**CAPITOL ZONING DISTRICT COMMISSION
STAFF REPORT
8/24/2016
TDM / BIM**

Location: 1814 South Spring Street
Applicant: Jason Jacob
Permit Type: Certificate of Appropriateness

Project Description: This application is for a Certificate of Appropriateness to allow the applicant to enclose several windows on a rear sleeping porch with lapped siding to match the adjacent walls, replace other windows, and replace siding on the porch.

Rear sleeping porch to be altered, as visible from the private driveway.

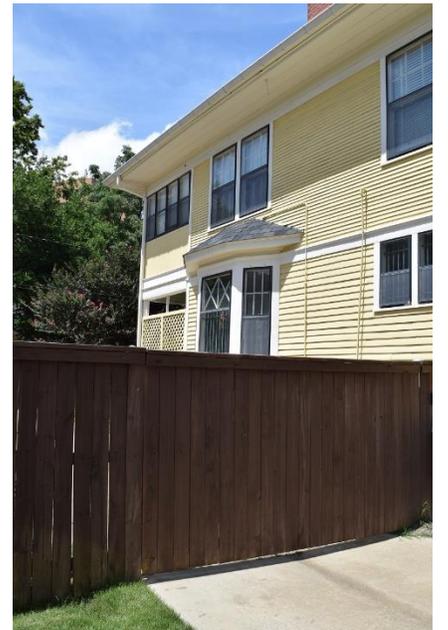
Staff finds the proposal is partially consistent with these principles. Further enclosure of the rear sleeping porch will not detract from the historic design character of the building. Staff believes, however, that the vertical bead board is likely an original building material to be preserved.

Staff finds the proposal to replace the vertical bead board siding is NOT consistent with these standards. Staff believes the existing siding is likely original to the house.

Staff finds the proposal is consistent with these standards. The rear sleeping porch was enclosed sometime in the past, and this application will further enclose some of the windows. The replacement casement windows appear similar to those commonly found on other enclosed rear sleeping porches in the neighborhood.

Based on the above findings, conclusions, committee recommendations, and the statement from the applicant that he plans to preserve the historic board and batten siding and will use board and batten siding in the window enclosures, staff recommends **approval** of the proposal with the following conditions:

- 1) That all applicable State and City codes be followed at all times;
- 2) That the property be maintained in a neat and safe condition at all times;
- 3) That the historic board and batten siding be preserved and that only damaged sections be replaced; and
- 4) That the windows to be removed be replaced with board and batten siding.
